## Planning Commission Staff Report

**SUBJECT:** DR18-34, RETAIL CENTER AT SANTAN VILLAGE

DR18-34: Retail Center at San Tan Village  
Attachment 4 - Site Plan  
June 6, 2018

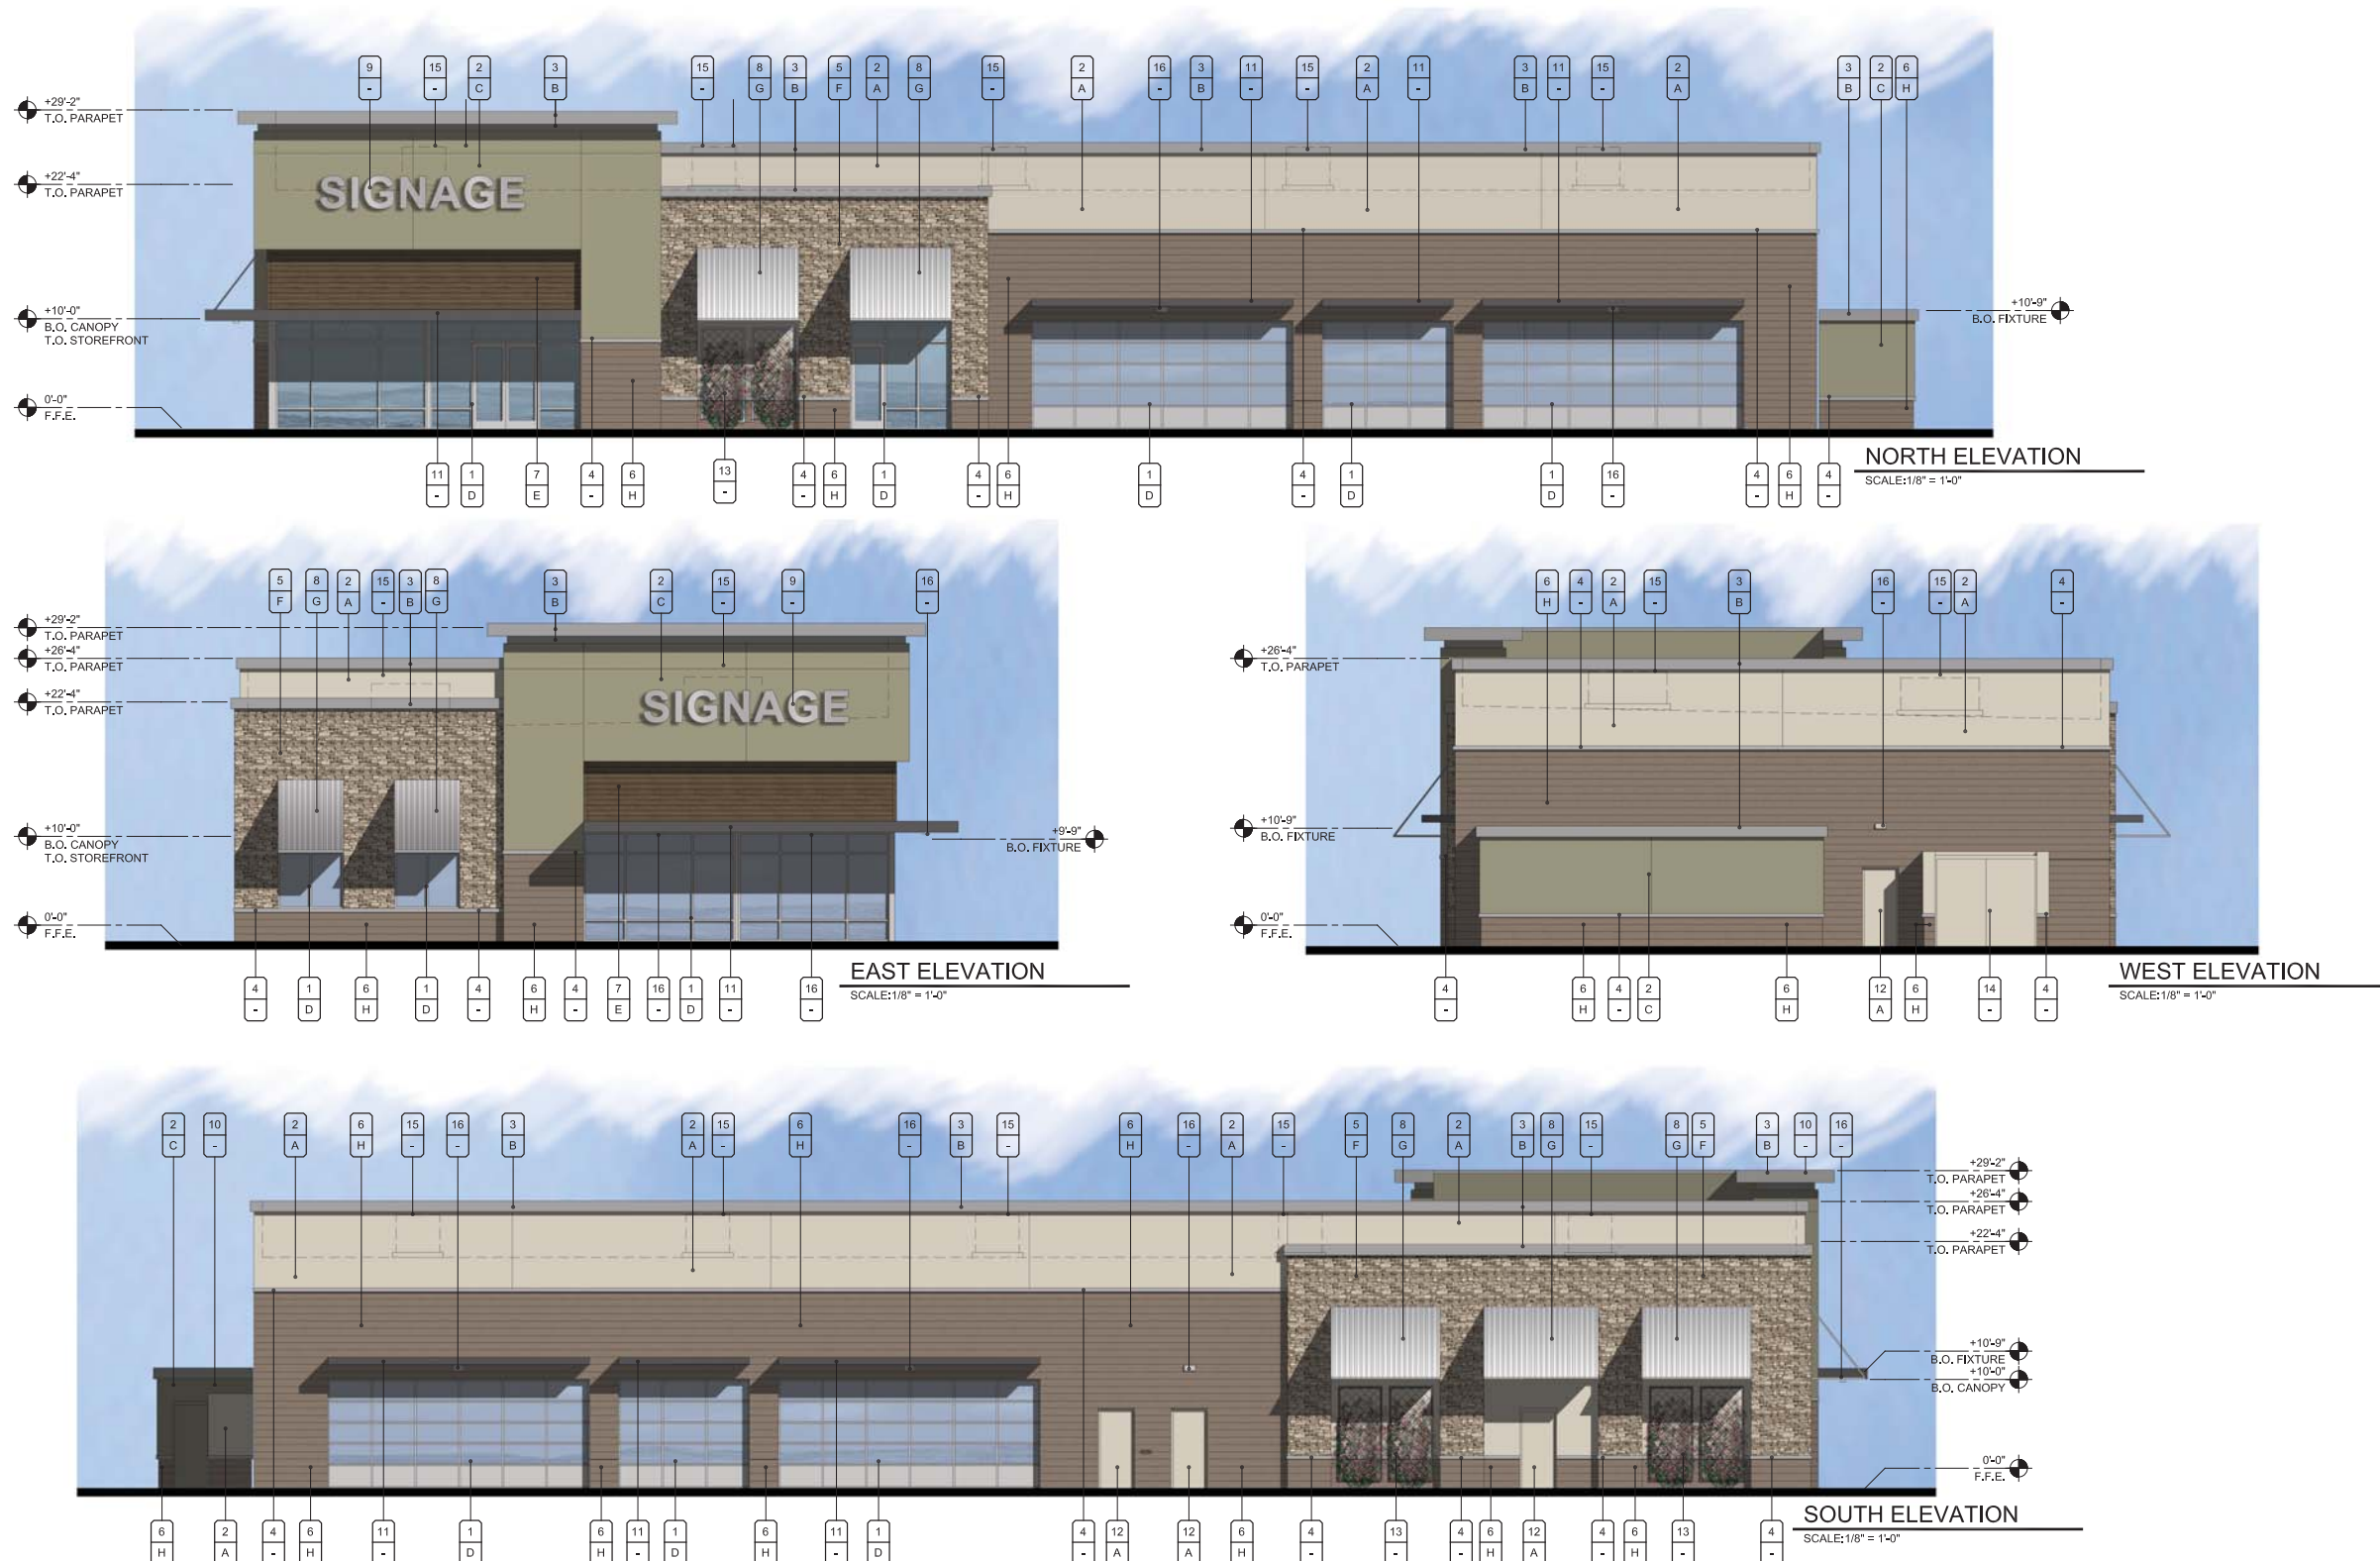
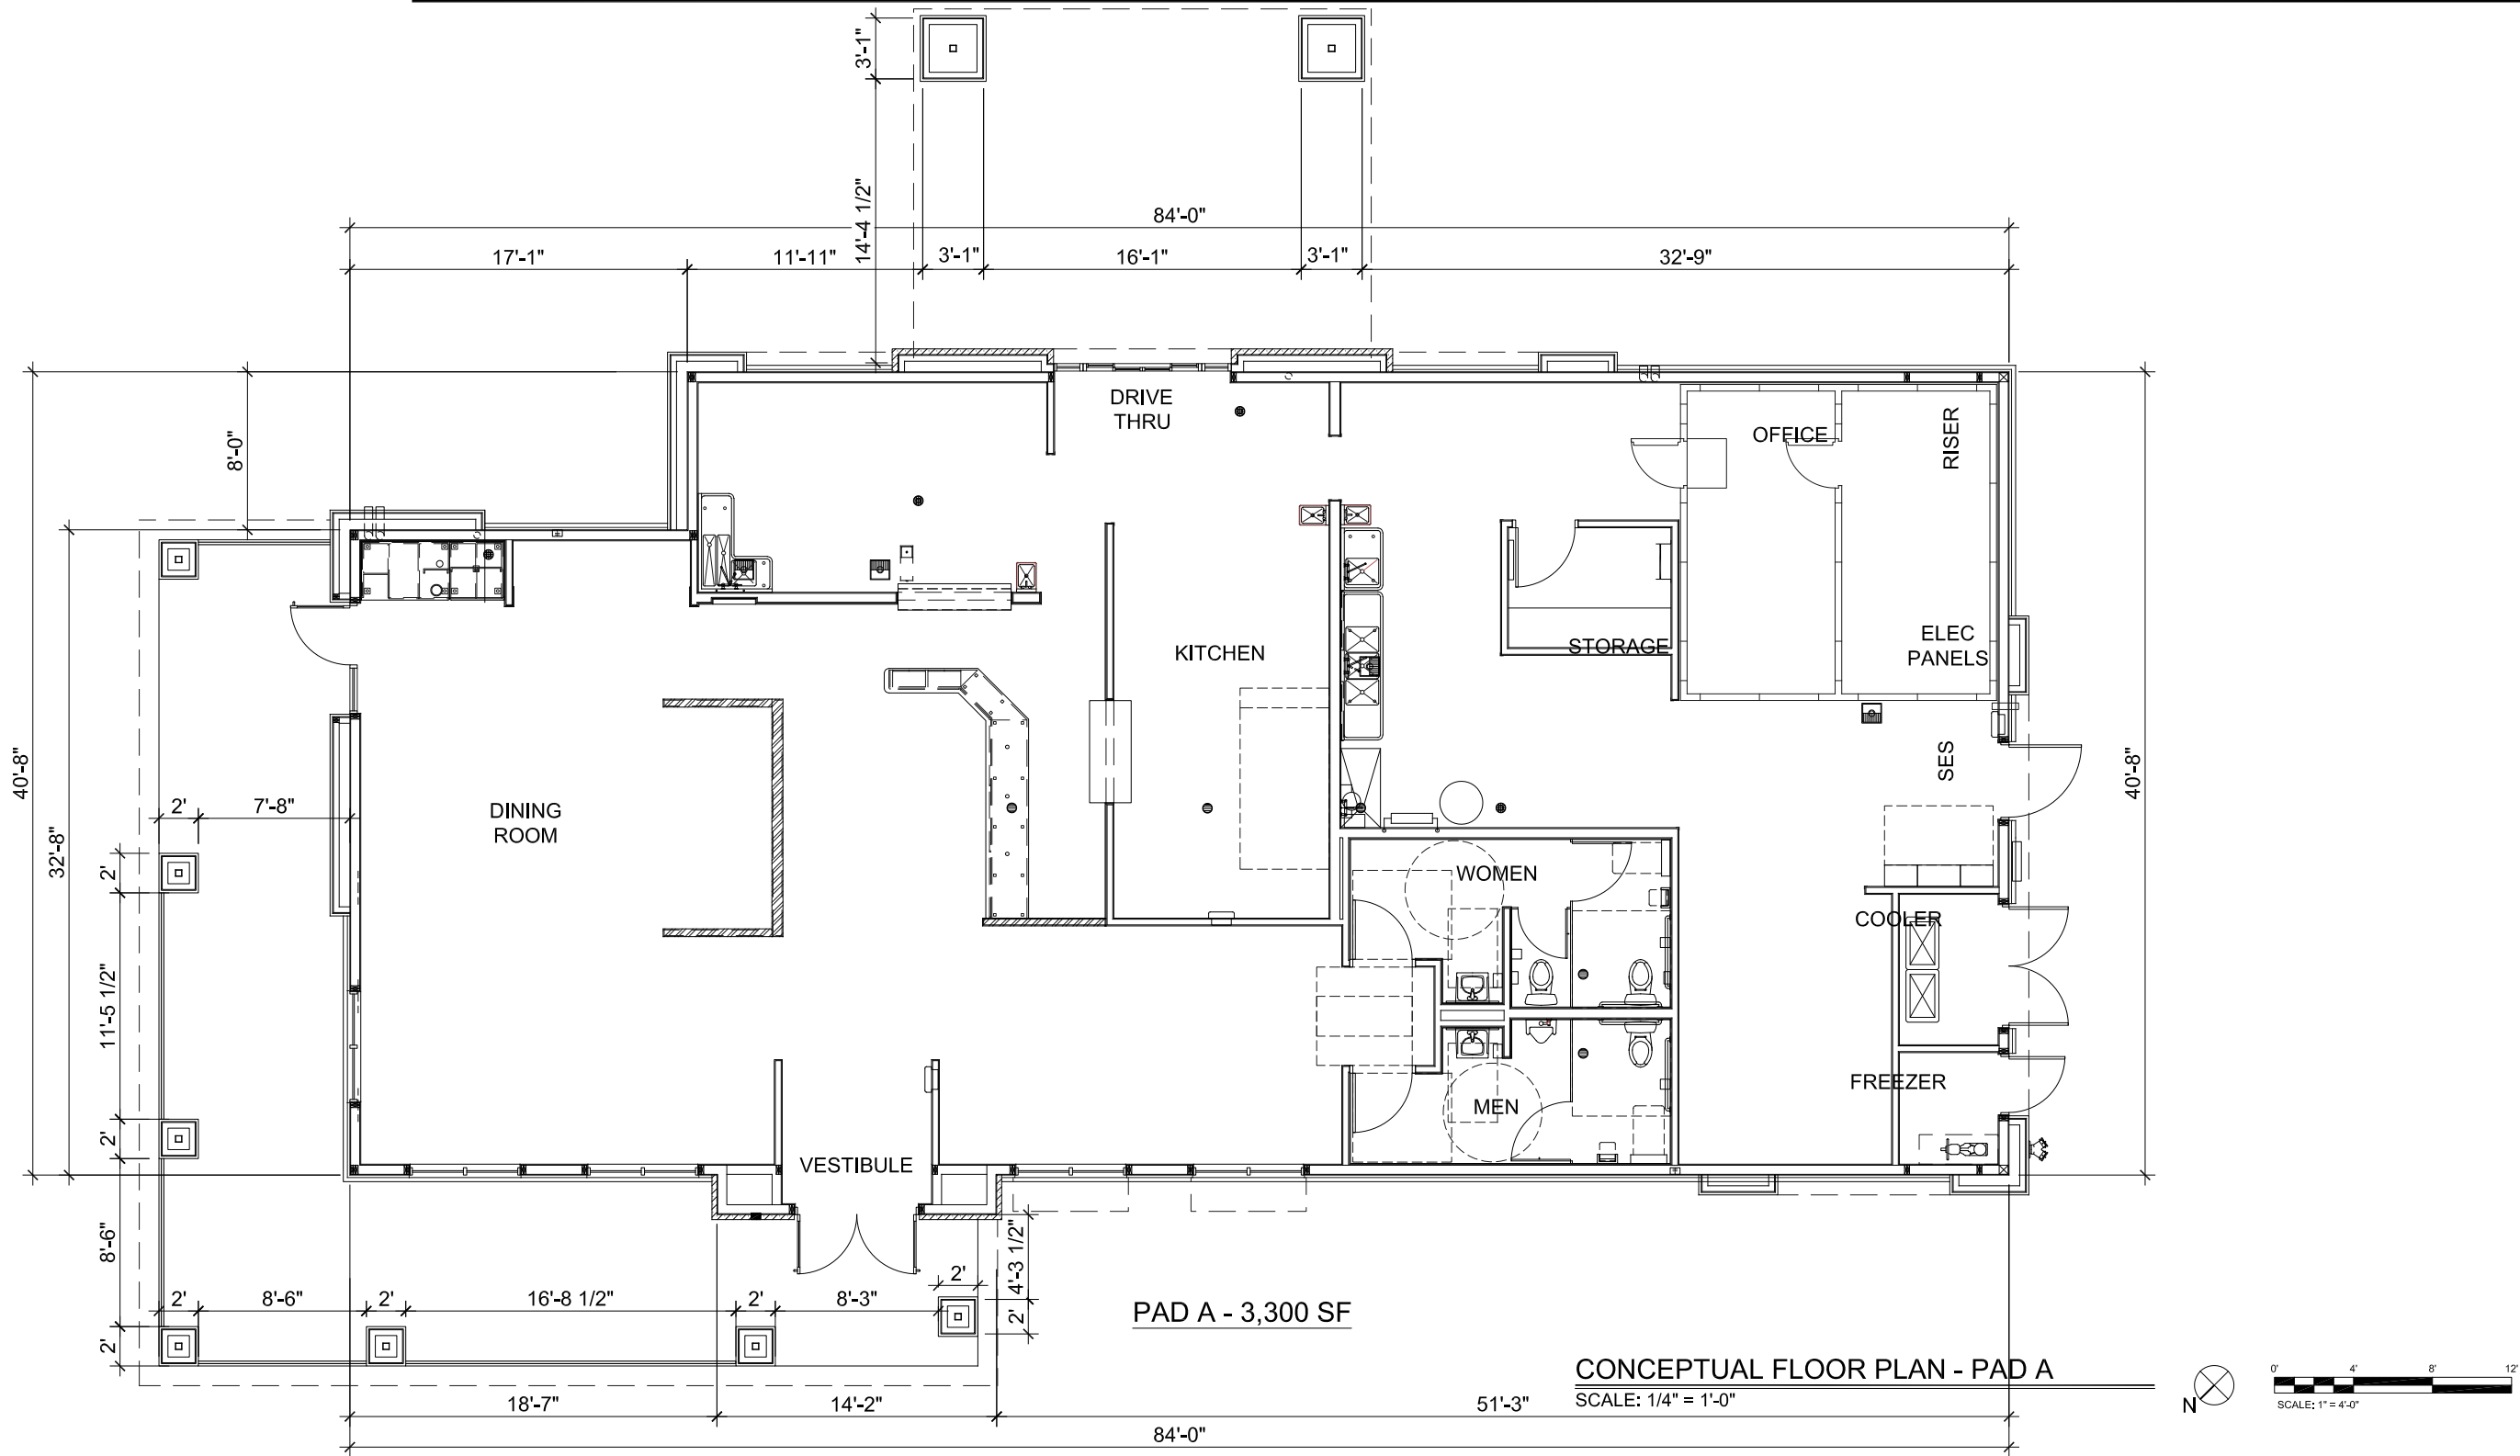
3. Commissioners requested more architectural features for south and east elevations on Pad A as they will be seen from Santan Village Parkway.
  - Pad A Elevations have been revised to add more articulation around the building. Stone has been added to the south elevation to enhance the Accessible Beige colored wall and break up massing. The stone feature wraps around to the west elevation. The stone accent and roofline on the north elevation has been further extended along the east elevation. On the east elevation, faux wood fiber cement board has been added on both sides of the drive-thru canopy area to provide more architectural features and make the building more appealing along Santan Village Parkway.

4. Commissioners noted the absence of architectural features around the bay doors on Pad B.
  - Pad B Elevations have been revised to include awnings over all bay doors, matching the awning at the main entrance. Superlite masonry block in Modesto has been added around the service bay doors on the north and south elevations, the block wraps around the west elevation.

Two doors relocated  
to underneath stone  
feature on south  
elevation.
